Rev A list of changes

PROJECT
200 THE BROADWAY, YMCA
LONDON, SW19 1RY

TITLE
Level 01 Plan

DRAWING NAME	PROJECT	ORIGINATOR	ZONE	LEVEL	TYPE	ROLE	NUMBER
YMCA	DLA		01	DR	A		241

Proposed First Floor Plan

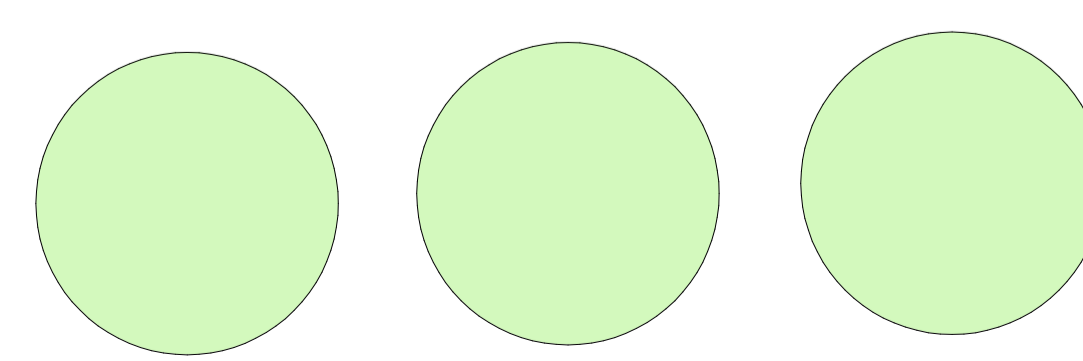
- Reduction in bedroom size in the 1b1p units.
- Addition of 750mm zone around beds in 1b2p central block units.
- Boundary treatment to ground floor duplexes on Trinity Road reduced from 1.5m height to 1.2m.
- Ground floor duplex gardens/bins store reconfiguration.
- Additional side door from servicing corridor to central commercial unit.
- Amendments to the enlarged cycle parking spaces to provide a secured and lockable store.
- Short stay cycle parking relocated from Trinity Road to central piazza.
- Provision of clear link from service yard to residential concierge lobby.
- Windows in YMCA amended to show perforated panels to avoid overlooking.
- Screen aligned with vertical mullions in central block façade facing The Broadway.
